# VNF Crissey Pumping Station

PUMP ASSESSMENT REPORT

**Report No:** 10031024-00522

**Work Package:** Evaluating current market and setting the basis for rolling out improvements

Figure 6 – Derived System Curves with Tabled and Alternative Xylem Selections at Design Head

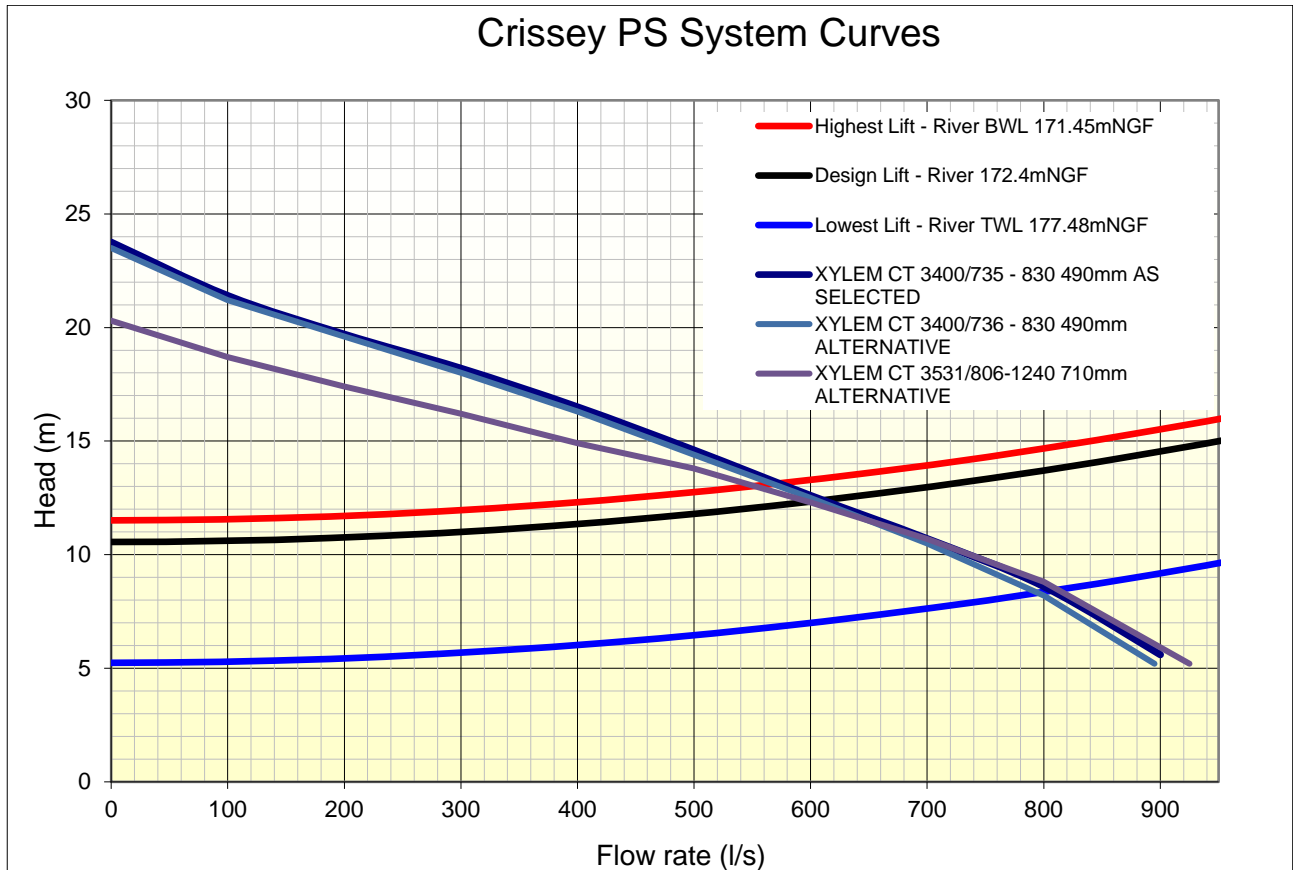
Xylem have undertaken their assessment and advised the selection of CT3400/735 ~830 490 mm impeller pump to meet the nominal flow of 600 l/s.

The results of the Arcadis review indicate that Xylem have since introduced a newer 8-pole motor model CT3400/736 ~830 490 mm impeller which essentially achieves the same performance as the tabled offer.

A further alternative is the 12-pole motor pump from Xylem, model reference CT3531/806 ~1240 710 mm impeller.

From the system curve, the pumped flows would reach approximately 800 l/s at minimum lift condition when the river level is high under a fixed speed drive arrangement. However, this would not cause any issues with the pump itself.

Figure 9 – Recommended Pipework improvements

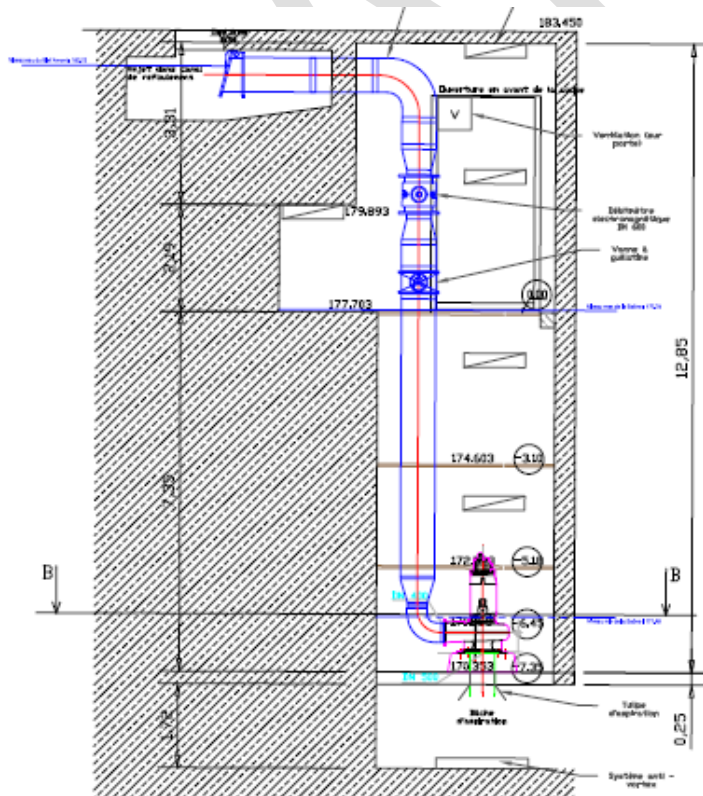
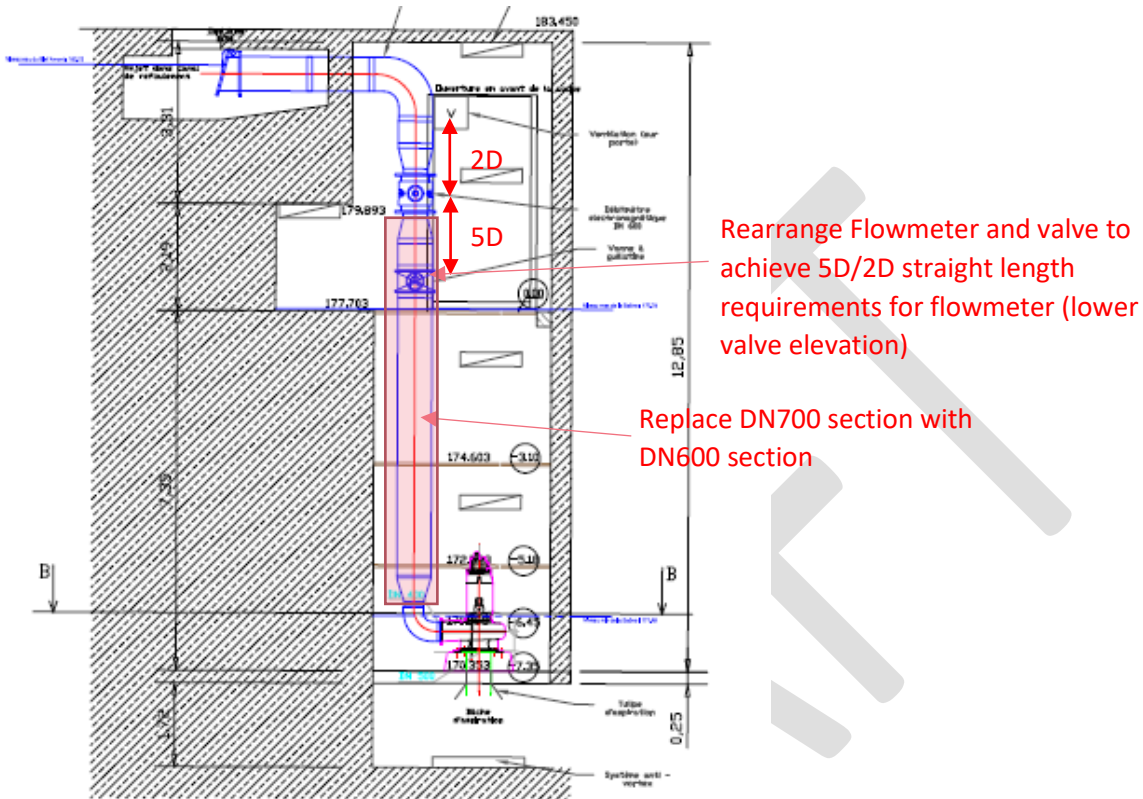
Focusing on the highlighted DN700 section riser section upstream of the DN600 flowmeter, the following observations are given.

1. The flowmeter requires a straight pipe section of 5 diameters upstream of the flowmeter is generally recommended. This section should be free of tapers and valves as shown. Therefore, it is suggested that valve position is moved to the landing level below that as shown, and therefore avoiding the potential to create any wake disturbances at the flowmeter measurement point.

2. It is noted that a 2.2 m/s velocity limit applies to VNF pumping station pipework in accordance with section 37 of CTCG Paper 73. At 800 l/s, a diameter of 700mm achieves this criterion, but 600 mm diameter pipe produces a velocity of 2.8 m/s. However, velocities below 3 m/s are still reasonable for short lengths, and we would recommend reducing the upstream pipework diameter to 600 mm as it will not adversely impact on the pump hydraulics and will achieve a better flow presentation to the flow meter. Also, it is expected that the additional friction losses from a smaller 600mm diameter pipe will be entirely offset by reduced point losses from reducing the expansion taper size and eliminating a reducer.

- Replace with proposed Xylem CT3400 pumps
- Continue with fixed speed drives.
- Install pipework of 600mm diameter upstream of 600mm diameter flowmeter
- Install an automated control system based on downstream (and upstream) level monitoring
- Install SCADA system and introduce performance metric reporting (e.g. pump power, flow data, etc.) and possible smart control adjustment.
